BLUE BIRD

SUBJECT: SERVICE BULLETIN S09PQ RACOR AIR FILTER REPLACEMENT PROGRAM

MODELS A3RE DIESEL BUSES OPERATING IN THE STATES OF
AFFECTED: CALIFORNIA, ARIZONA, WASHINGTON, AND UTAH
IN HIGH DUST ENVIRONMENTS

Air Cleaner Replacement

New RACOR Air Cleaner

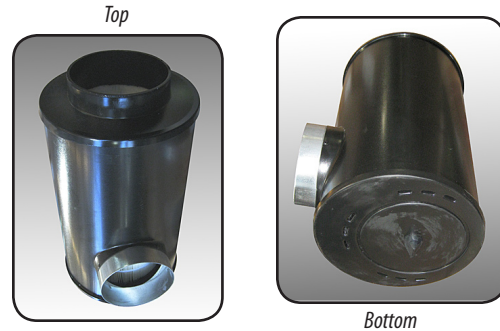
New RACOR Air Cleaner designed for A3RE to alleviate potential problems with the old air cleaner.

Replace old air cleaner with metal end caps with new RACOR air cleaner constructed with composite material end caps. Review and follow maintenance procedures and replacement criteria for air cleaner.

3.1 If the air cleaner is equipped with metal end caps, replace with new design (Blue Bird #01967744) Racor air cleaner. Follow replacement instructions in the Intake & Exhaust Chapter under Intake System Maintenance of the Blue Bird A3 Maintenance Manual.
